TECH BULLETIN # 3

MODEL - 924S,944/S/T

SUBJECT - OIL COOLER AND OIL PRESSURE RELIEF VALVE

Figure 1

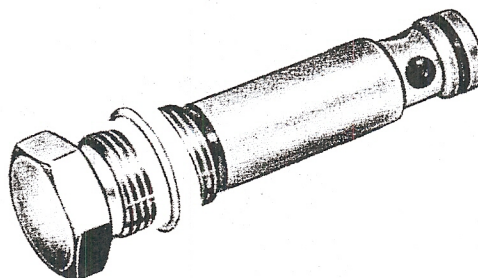
From start of production 1983, 944 cars came equipped with a spring and piston oil pressure relief valve (figure 1). This was used in all 944 and 944 Turbo up to the end of 1986 production. Also early 1987 924S used this system. In 1987 production of 944, 944S and 944 Turbo, a new type one-piece oil pressure relief valve PN 944 107 035 01 was installed (figure 2). Later production 1987 924S also received this valve. At around the same time a new type one-piece pressure relief valve, PN 944 107 035 11 was introduced as a retrofit to repair earlier engines from 1983 to 1986 along with the early 924S. With this, the old type spring and piston was discontinued as a spare part.

**Up to and including 1986 Model Year
original equipment.
Three piece oil pressure relief valve.**

Fig. A

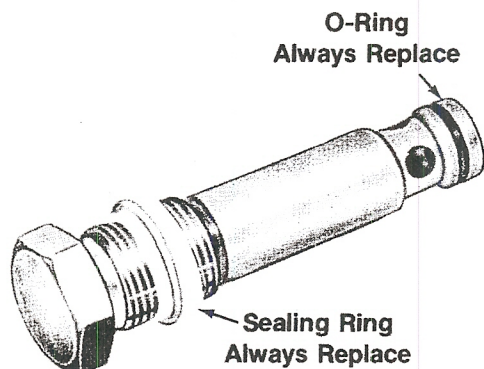
Since these new type valves are similar in design, the following information will aid in determining the correct oil pressure relief valve application.

YEAR	MODEL(S)	QUALIFIER	VALVE TYPE
1987	924S	Up to engine # 43 H 01919-std. trans. 43 H 60384-auto. trans.	Fig. A
1987	924S	From engine # 43 H 01920-std. trans. 43 H 60385-auto. trans.	Fig. B
1983-86	944, 944 Turbo	All	Fig. A
1987	944, 944S 944 Turbo	All	Fig. B

9215

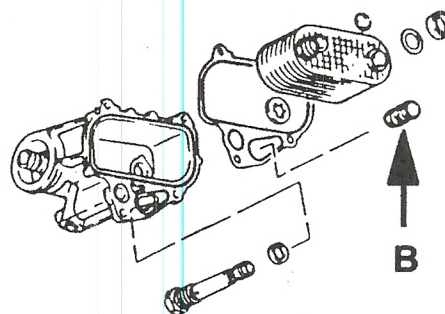
NOTE: Special tool 9215 is only used in engines having a steel sleeve installed in the oil pressure relief valve passage (1983-1986). It is important that the sleeve (arrow B below) be firmly installed in the crankcase. If loose, the oil cooler housing must be removed and the sleeve secured with loctite 648 or 638. Drive the sleeve to stop with special tool 9215. Consult the 944 Workshop Manual Vol. I, page 17-22 for additional instruction.

Figure 1

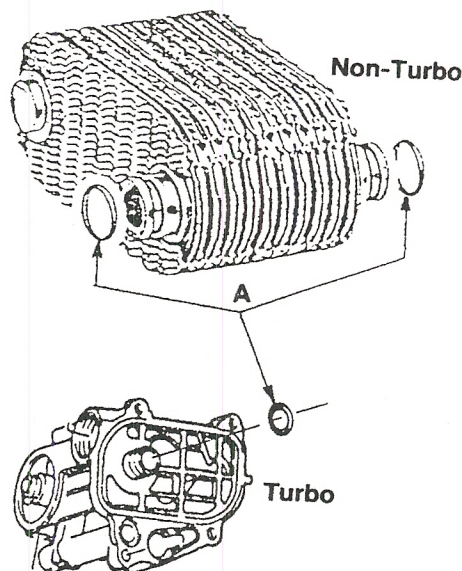
1. Plastic washer installed between housing and oil cooler.
2. Housing - Guide drilling reworked.
3. Adjustment shims between cooler and crankcase installed.
4. Rubber ring (always replace when servicing).

To determine if the oil cooler housing is the latest version, and to help prevent needless housing replacement, inspect as shown.

A - original design
B - new design

The sealing O-rings (A, figure 1) located on the oil cooler of normally aspirated cars and on the connecting pipe of the oil thermostat housing of Turbo cars, have been changed. The new version O-ring is now green in color (formerly red). When repairing, use ONLY the new version green O-rings PN 999 707 043 40.

Please note that the O-ring "A" in Fig. 1, is also installed in 944 Turbo cars. There are two O-rings on a short connecting pipe in the same place as they are found on normally aspirated cars.

When repairing earlier cars, the new type housing, plastic washer, and adjusting shims must be used.

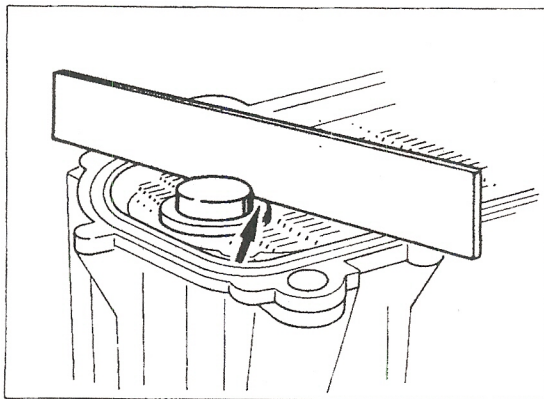
Install new version O-rings onto oil cooler. Install plastic washer onto cooler guide boss (use light grease to hold washer in place if necessary). Lubricate cooler O-rings with oil to prevent rolling and insert cooler into housing. Use straightedge on housing and determine distance between oil cooler guide boss and straightedge (see photo below). With shims installed, measurement should be $0 \pm 0.25\text{mm}$. The oil cooler housing gasket is **NOT** included in the measurement. Thickness of one shim is 0.5mm.

Before installing cooler assembly, mount a new rubber ring (arrow 4) onto crankcase and hold in place with light grease or Curil.
